Rezoning Transportation Analysis

Petition Number: 2024-037

Date	Description
4-24-24	First Review (JT)
4-24-24	Second Review (TM)
08-22-24	Third Review (TM)

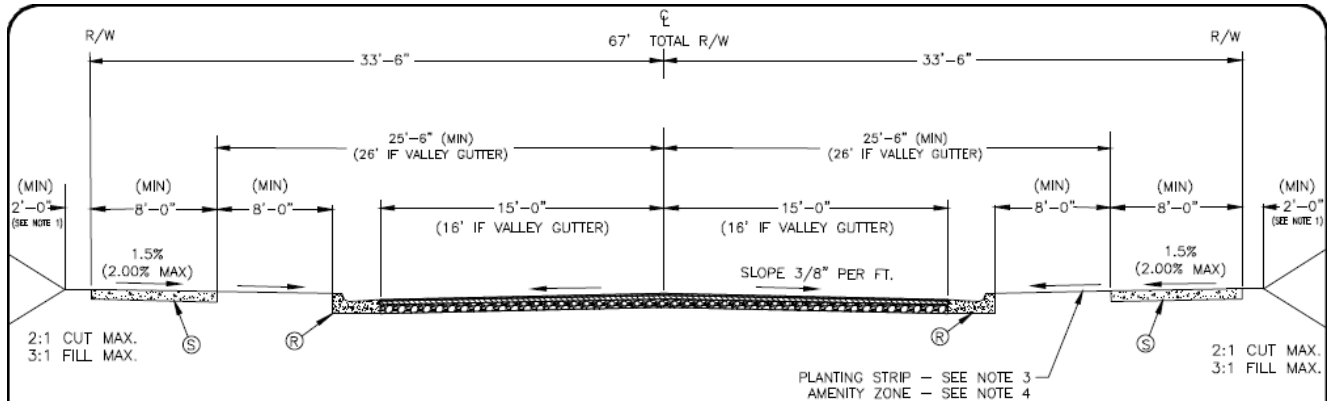
- b. **W 28th Street:** Location of future curb and gutter is to be 17.5 feet from the roadway centerline per CLDSM U-07B.

Label and dimension the curb and gutter from the centerline for each road on the site plan.
